Ref: Ref DA: D/2020/1211, 48-64 Wentworth Park Road GLEBE, NSW, 2037

The Glebe Society objects to the DA to change the roof form and increase the height of 48-64 Wentworth Park Road, Glebe and to changes proposed for the ground floor façade of the building facing Wentworth Park Road.

Figure 1 ERL Pty Ltd, 48-64 Wentworth Park Road, Glebe, 1937 City of Sydney Archives

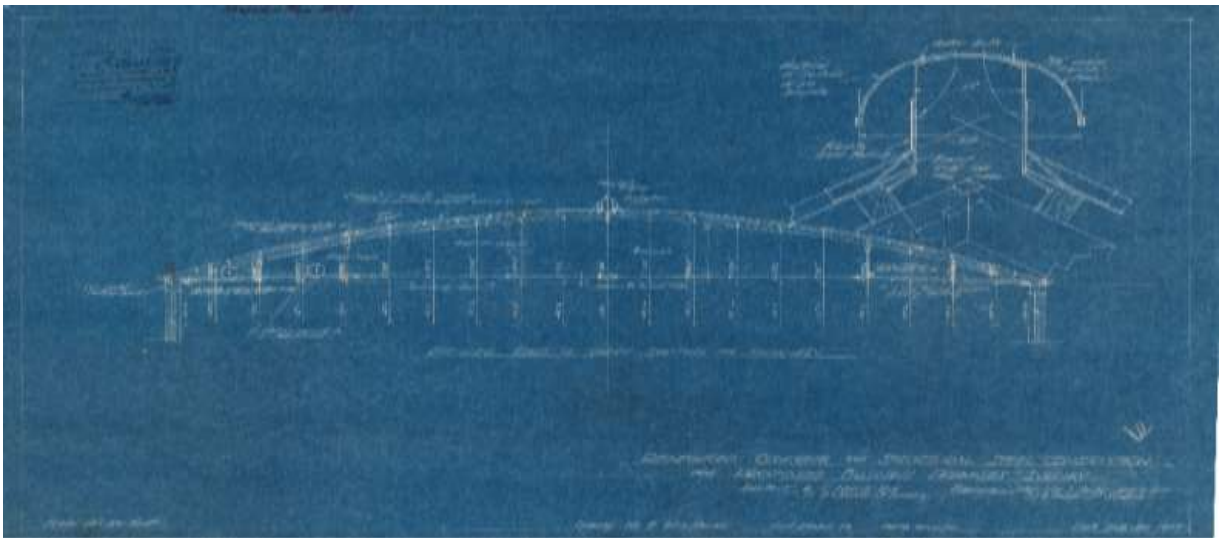
As identified in the LEP this is a high-quality, beautifully articulated, inter-war industrial building. One of its distinguishing features is its arched roof form, the plan of which is illustrated in Fig 1 below.

The HIS states that the curved roof was a *later addition* (Brelco Build to Rent HIS, p. 19), however, this is not the case as the City of Sydney Archives show it was the result of a design amendment prior to construction.

Figure 4 shows the proposed rooftop addition which is misdescribed in the application as a rooftop conversion

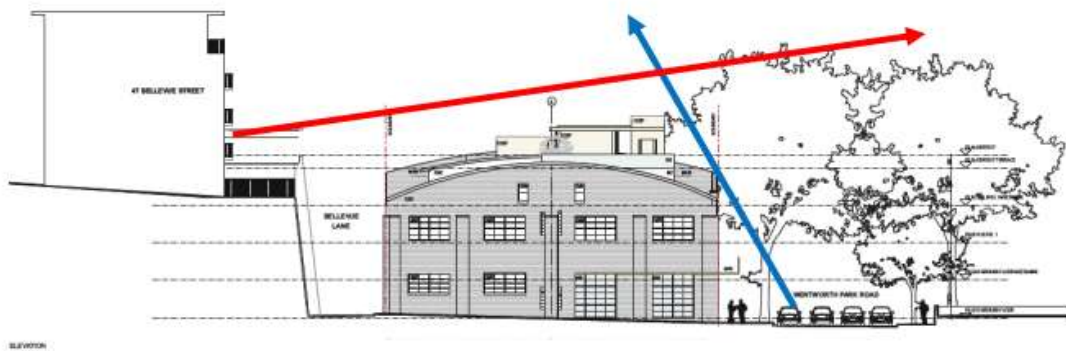
Figure 2 shows the original roof form

Figure 3 shows the 2005 attic insertions which retained the legibility of the curved roof

The application asserts that this is a minor building addition.

It is not as it significantly changes the form and appearance of the building. The applicant's assessment of the impact of the addition on views of the façade of the building is inaccurate and misleading (see Fig 5 below).

Figure 5 The view misleading assessment of the rooftop additions impact on views contained in the application.

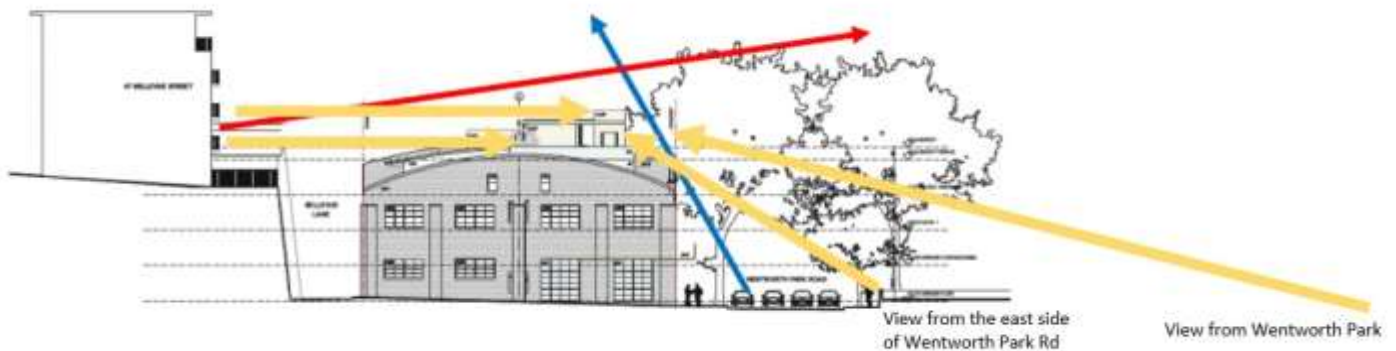
The building's location across the road from Wentworth Park allows for distant views thus giving it a higher degree of visibility than in a conventional street. The street trees on Wentworth Park Rd are deciduous which means the addition will be clearly visible in winter and it is simplistic to argue that views from the Bellevue Street apartments will not be affected. The viewing point has been aligned so the vista is screened by the brick pediment but most of the façade is not screened in this way. A more accurate assessment of the impact on views is contained in Figure 6 below.

**Figure 21** The new rooftop terrace will not adversely impact views from Wentworth Park Road (blue arrow), and only negligibly affect views from Bellevue Street apartments to the CBD due to the existence of street trees (red arrow).

Figure 6 The yellow arrows show the true impact of the roof top addition on views from the Bellevue Street apartments, the eastern side of Wentworth Park Rd and from within Wentworth Park

Figure 7 The white line shows the current non- conforming 11.9 metre building height in relation to the precinct and the red line shows the proposed 15.5 metre height.

The 9-metre height limit is designed to preserve the scale of the streetscape and the topography of the HCA with its steep slope from the reclaimed land of the former Blackwattle Bay (now Wentworth Park) to Bellevue Street. As figure 7 shows 48-62 Wentworth Park Road is already the highest building in this part of the Heritage Conservation Area and the increase in its height to 15.5 metres would reduce the legibility of the topography.
